# 915 Collins Street, Docklands (1 Collins Wharf)

Planning Permit Application No. PA1500038

Officer Assessment Report

Figure 8 - Proposed height & location of 1 Collins Wharf

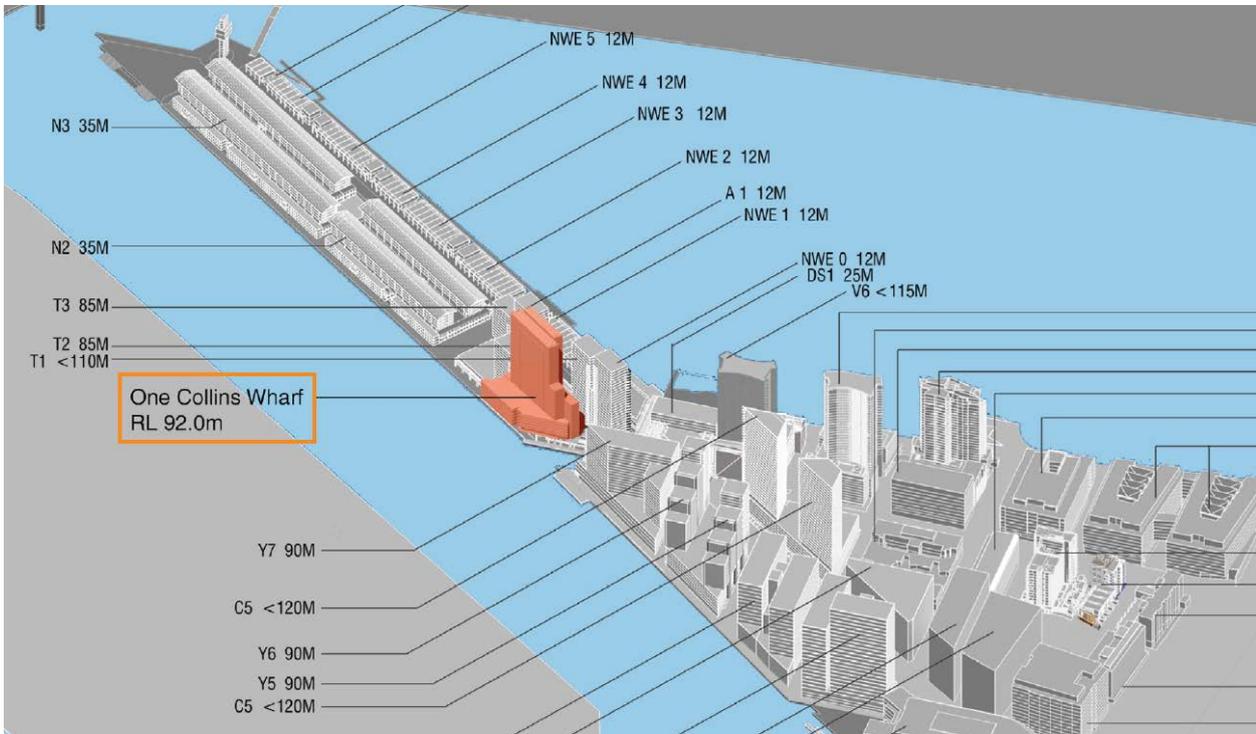
The proposal for the subject site includes a single tower with a height of just over 90m. The height of the building is therefore generally in accordance with the built form provisions of the Development Plan as they relate to the subject site.

Figure 10 - Indicative section & artist's impression, proposed Yarra Walk

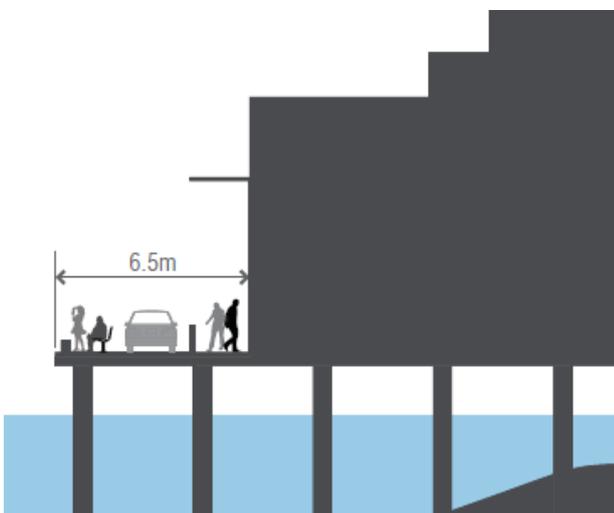
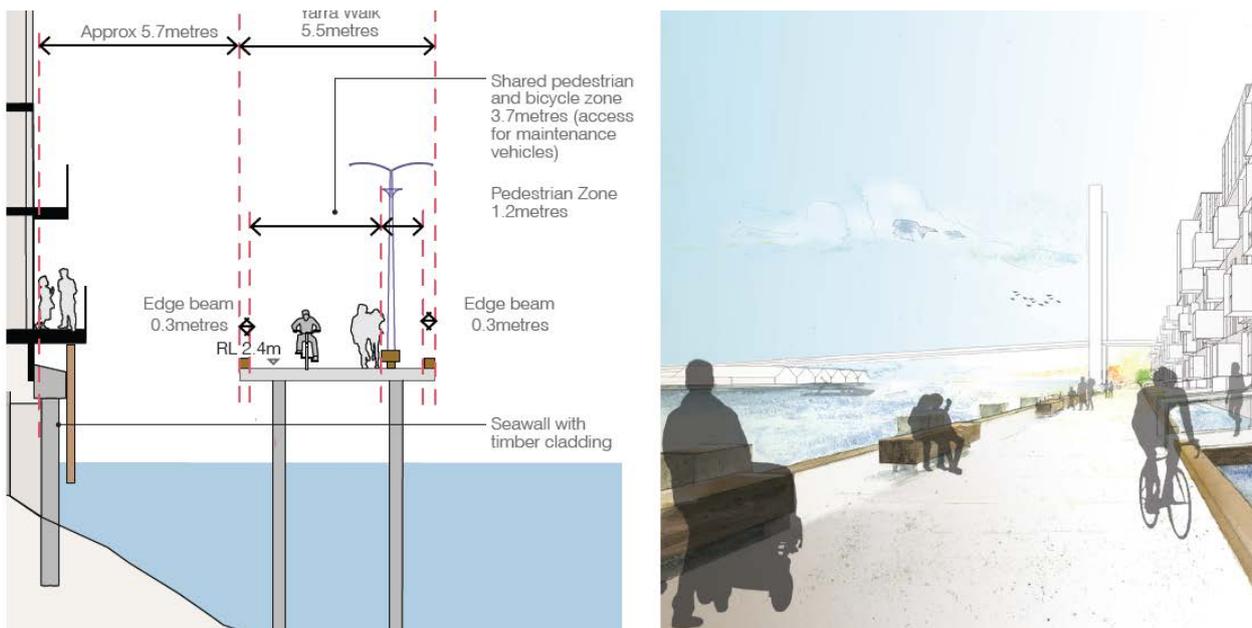
The proposed configuration represents a departure from the provisions of the Development Plan. The on-wharf 6.5m public promenade (formerly Australian Wharf Promenade West) is now proposed to be a 5.5m wide over-water boardwalk (Yarra Walk), separated from the southern edge of the building by a 5.7m wide passage of water. The boardwalk would continue along the full length of Collins Wharf (and is included as part of the separate application to amend the Development Plan).

While this is a departure from the Development Plan, the proposed arrangements are nevertheless considered to be acceptable, based on the following considerations:

- The reduced width of the boardwalk is still considered to be sufficient in terms of pedestrian amenity. Furthermore, Melbourne City Council's Engineering Services Group have confirmed that the boardwalk can function successfully and will provide adequate service vehicle access.
- Pedestrians and cyclists will continue to have priority on the promenade/boardwalk, given its commencement at a key public space (Bourke Dock) to the east of the wharf, and termination at another key public space (John Coode Park) at the western end of the wharf. The boardwalk is proposed to be fitted with seats where appropriate which will encourage visitors to utilise and engage with the space. Furthermore, the boardwalk incorporates landings at the junctions with the north-south laneways to further enhance pedestrian circulation and amenity.

Overall, the proposed southern promenade arrangements are considered to be generally in accordance with the Development Plan. Yarra Walk will continue to provide a pedestrian waterfront experience, and represents a variation to the typical promenade arrangements provided elsewhere throughout Docklands which recognises the uniqueness of Collins Wharf.

Figure 14 - Staging plan

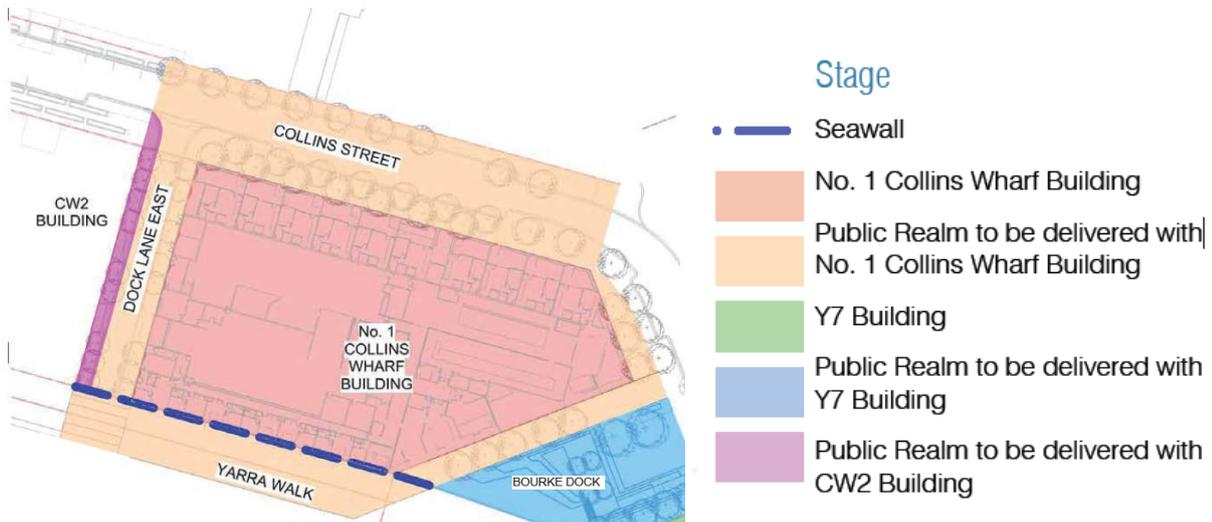
In relation to the proposed staging and ownership arrangements, the documentation submitted indicates that the proposed building will be delivered in conjunction with the associated public realm works of Collins Street (immediately opposite 1 Collins Wharf), Yarra Walk, and the south-eastern and north-eastern footpaths adjacent to the building.

Figure 15 - Land ownership

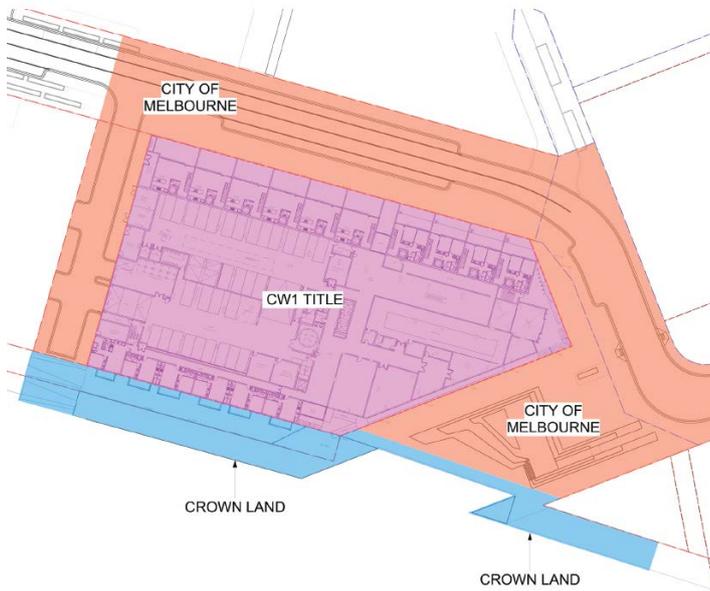
The proposed ownership arrangements are consistent with development throughout Docklands and are supported by Places Victoria and Melbourne City Council.

Figure 16 - Solar access to typical promenade vs. Yarra Walk

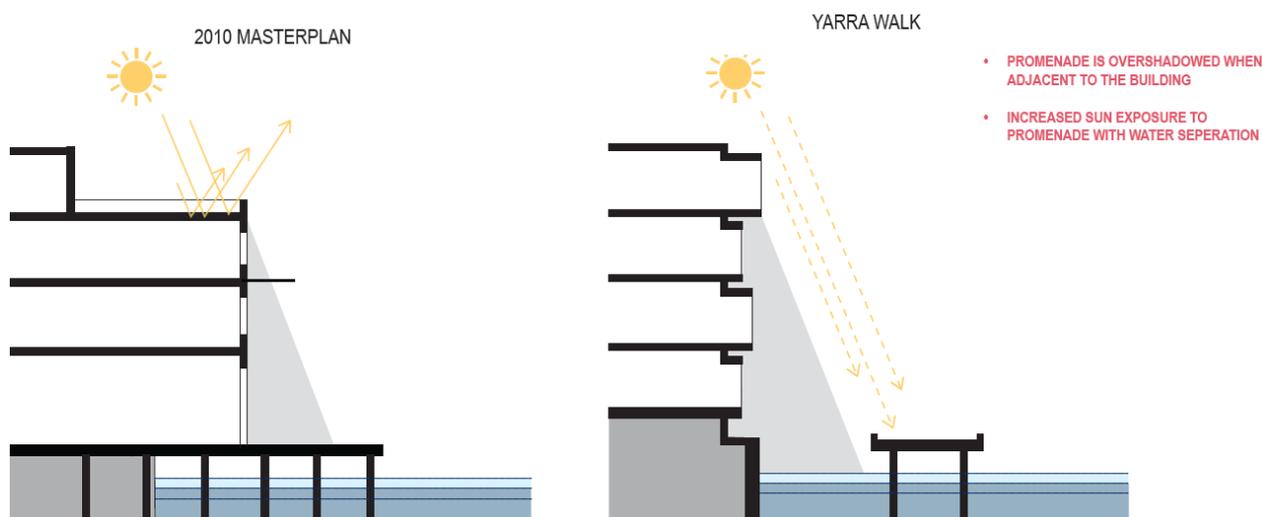
The proposed Yarra Walk configuration will result in improved daylight conditions to the southern promenade, as a result of the increased setback from the wharf line.

The proposal will result in some overshadowing of the Yarra River corridor, which was an issue raised by Melbourne Water. As the height and built form enveloped of the proposed building is consistent with the approved Development Plan, it is acknowledged that some overshadowing of the river will inevitably result from development on the northern bank of the river. The Melbourne Planning Scheme does not contain any policies relating to overshadowing of the river, and the proposal is therefore considered to be acceptable.

Overall, it is considered that the overshadowing impacts are consistent with what was envisaged under the Development Plan and accordingly are acceptable.
